Project	IEEE 802.16 Broadband Wireless Access Working Group < http://ieee802.org/16 >
Title	Harmonized Relay Frame Structure
Date Submitted	2009-01-05
Source(s)	<p>Jerry Sydir, Alexander Maltsev, jerry.sydir@intel.com Honggang Li, Alexei Davydov, Rui Huang Intel Corporation</p> <p>Rakesh Taori, Youngbin Chang rakesh.taori@samsung.com Samsung Electronics</p> <p>Shashikant Maheshwari, Adrian Boariu, shashi.maheshwari@nsn.com Yousuf Saifullah Nokia Siemens Networks lsun@lge.com</p> <p>Li-Hsiang Sun , Ki-Dong Lee LG Electronics, San Diego, USA</p> <p>Aeran Youn *<http://standards.ieee.org/faqs/affiliationFAQ.html> LG Electronics, Anyang, Korea</p>
Re:	TGm SDD CfC (IEEE 802.16m-08/052) – Section 14.4.4
Abstract	This contribution proposes a harmonized relay frame structure which combines features of the option 1 and 2 frame structures.
Purpose	For consideration and adoption into the 16m SDD document.

Harmonized Relay Frame Structure

Figure 33 Relay Frame structure ~~option 1~~

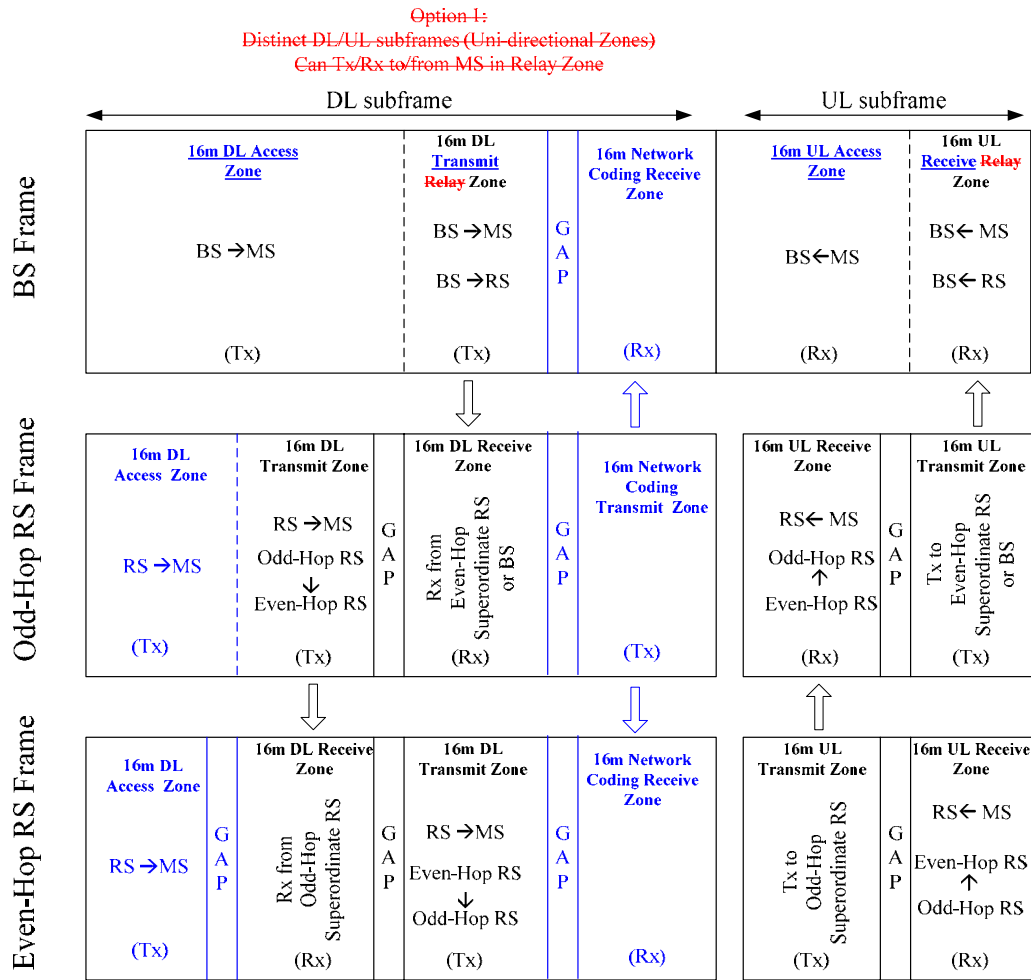
~~There are two options for the Relay frame structure. These are captured in Figure 33 and Figure 34. Further study is required to distill a single frame structure from among these two options. The Relay frame structure is illustrated in Figure 33.~~

[Modify figure 33 on page 68 as indicated below]

[Modify the caption of figure 33 on page 68 as indicated below]
